**Remediation System Evaluation (RSE)  
Tutu Wellfield Superfund Site**

**St. Thomas, U.S. Virgin Islands**

Report of the Remediation System Evaluation  
Site Visit Conducted at the Tutu Wellfield Superfund Site on  
February 8, 2011

Final Report

Figure 2-1  
Site-Wide Groundwater Elevations and CVOC Concentrations  
April 2010 RA Progress Report  
Tutu Wellfield Site, St Thomas, USVI

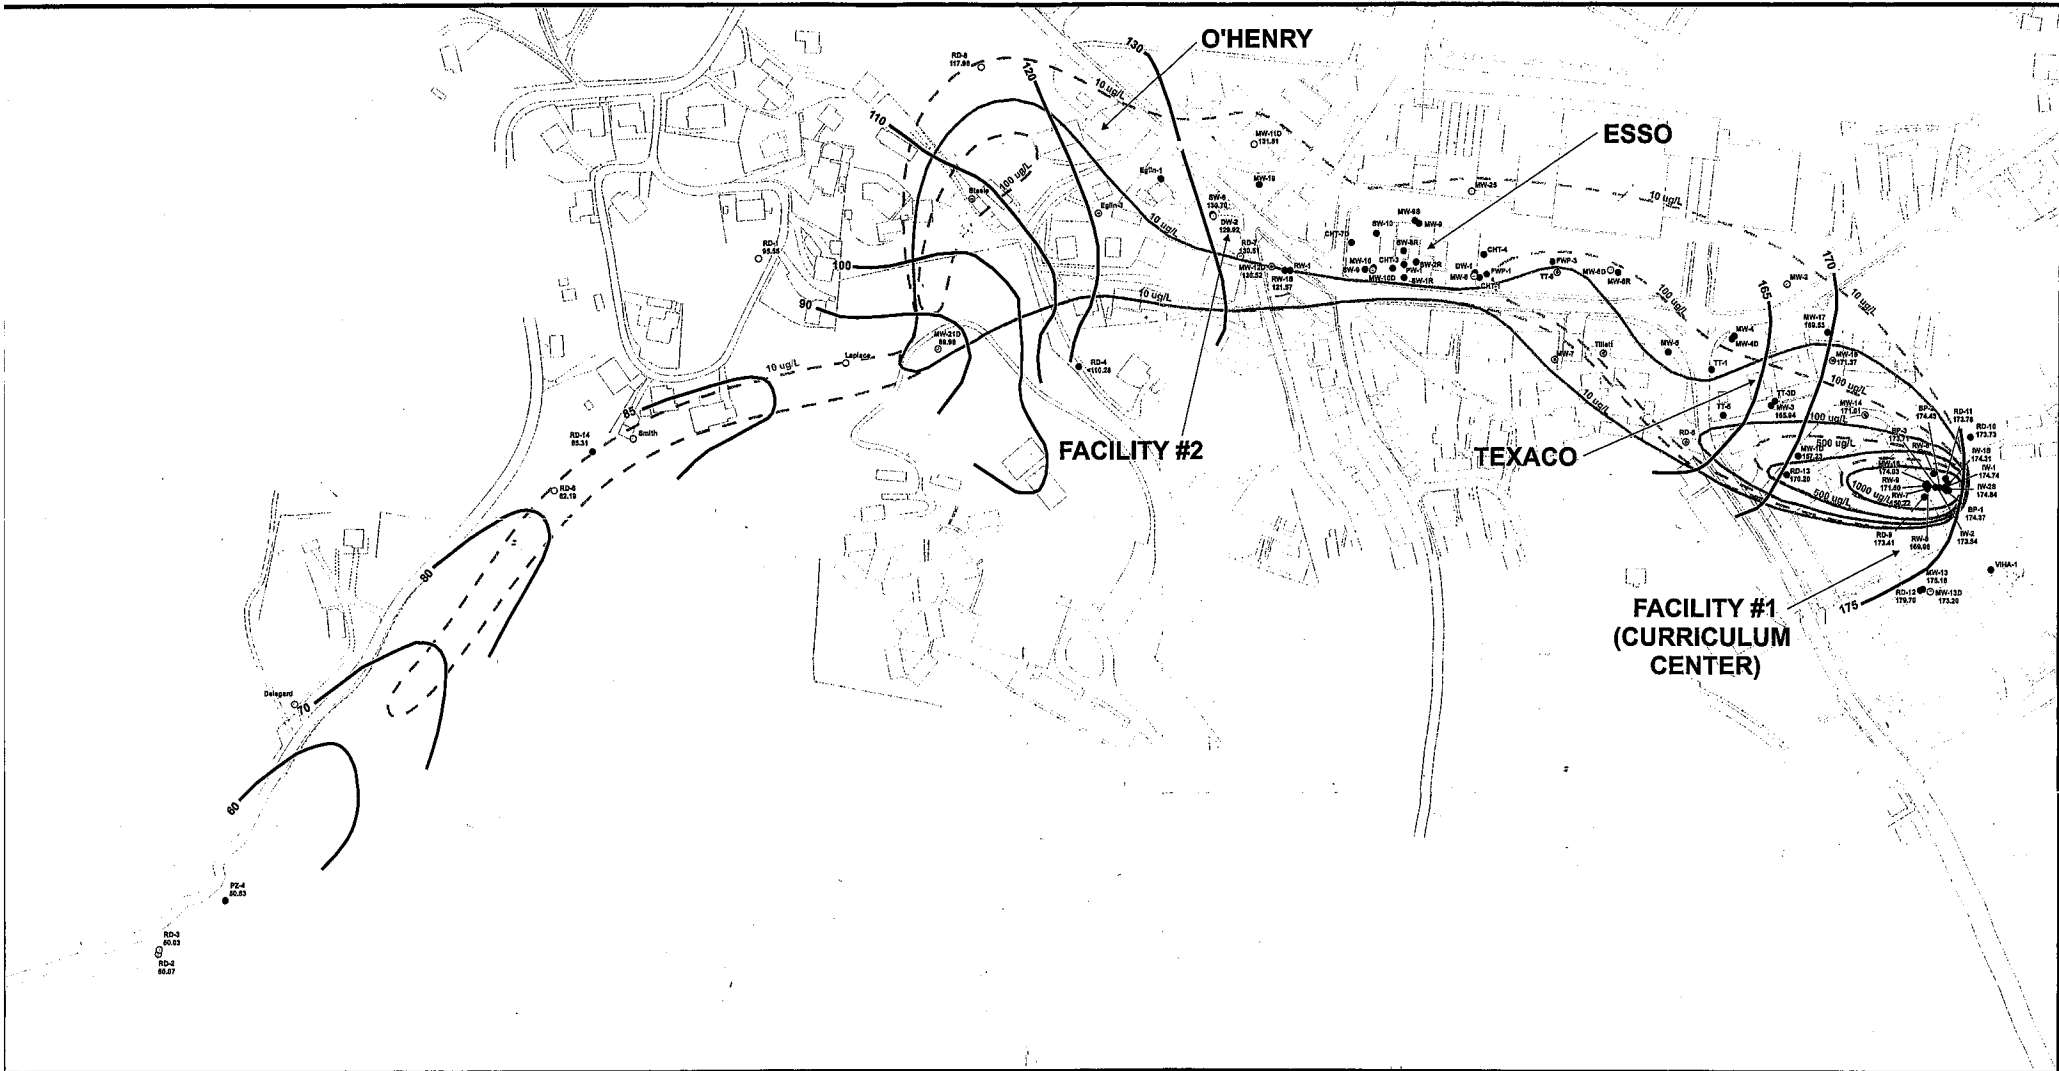
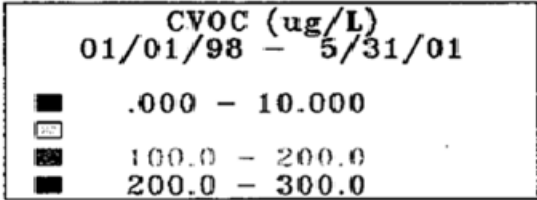
The first figure in Appendix A shows the interpreted potentiometric surface in and around the CVOC plume(s) associated with the Tutu Wellfield Superfund Site in April 2010. The northern and upgradient end of the plume is at the Curriculum Center near GWTF #1. In this area, the potentiometric contours (particularly at 175 feet above mean sea level) are interpreted by the contractor (CDM) to bend in a way that suggests converging flow (toward the extraction wells). However, the exact location and shape of these contours is not entirely supported by the water-level data posted on the map (two of the four water levels posted upgradient of the 175-ft contour are less than 175 ft). It is likely that the shape of the head contours reflects the conceptual model of groundwater flow converging from the east and west into the bedrock valley that controls the migration of the regional CVOC plume. In any case, the contours as drawn suggest that the capture width from extraction wells RW-7 and RW-9 would be approximately 75 ft or less. However, the 100- $\mu\text{g/L}$  CVOC plume is approximately 200 ft wide in this area. Water-level data at approximately twelve wells in very close proximity to the extraction wells (within approximately 100 ft of RW-7) could probably be analyzed in further detail on a zoomed-in map to better define the shape of potentiometric contours and capture zone. For such an analysis, measured water-levels at active extraction wells should not be used due to well losses. However, this type of analysis could be complicated by vertical hydraulic gradients. It does not appear that such an analysis would indicate a capture zone width greater than approximately 75 ft and certainly it would be much less than 200 ft.

For purposes of this evaluation, it is assumed that the target capture zone is the CVOC plume greater than 100 µg/L (total) at the Curriculum Center. It is assumed that lower concentrations of CVOCs would be remediated by natural attenuation or captured in the downgradient system at GWTF #2. The width ( $w$ ) of the target capture zone is approximately 200 ft as measured from the figure in Appendix A.

Using this same figure, the hydraulic gradient ( $J$ ) is estimated to be 0.02 (10 ft head drop over approximately 500 ft distance) on average at the Curriculum Center. However, the gradient apparently increases toward the south and is somewhat uncertain. Therefore, calculations were made using a reasonable range of hydraulic gradient between 0.015 (5 ft drop over 330 ft) and 0.025 (5 ft drop over 200 ft).

Review of the map in Appendix A indicates that there are insufficient water-level data in the vicinity of RW-1S from which to draw a potentiometric surface of sufficient detail to evaluate plume capture near GWTF #2.

As indicated in Section 4.2.1, the interpreted capture zone associated with GWTF #1 is small relative to the size of the high-concentration portion of the plume (e.g., greater than 100 µg/L CVOCs). RW-7 is too far upgradient to effectively contain the Curriculum Center source area. A new containment system including a line of wells perpendicular to the flow direction screened through the shallow and deep zones near RD-13 (300 ft downgradient) should be considered. The plant is designed for up to 60 gpm so additional flow can be taken.

To attain 50 gpm extraction, approximately four new extraction wells are likely to be needed, each capable of pumping up to approximately 18 gpm (similar to the extraction rate at existing well RW-7). This will allow 50 gpm to be attained when one well is off line for maintenance. The number and spacing of wells to add should be evaluated based on: (1) review of the available geologic information and the currently available hydrogeologic data (e.g., boring logs for existing/past nearby monitoring and pilot scale treatment wells and historical water level data under operating conditions); and (2) field testing (e.g. specific-capacity testing) of the new wells during installation. The new extraction well system should be designed to attain capture of the high-concentration portion of the CVOC plume; this will also address deep contamination that slowly partitions upward into the capture zone of the extraction system.
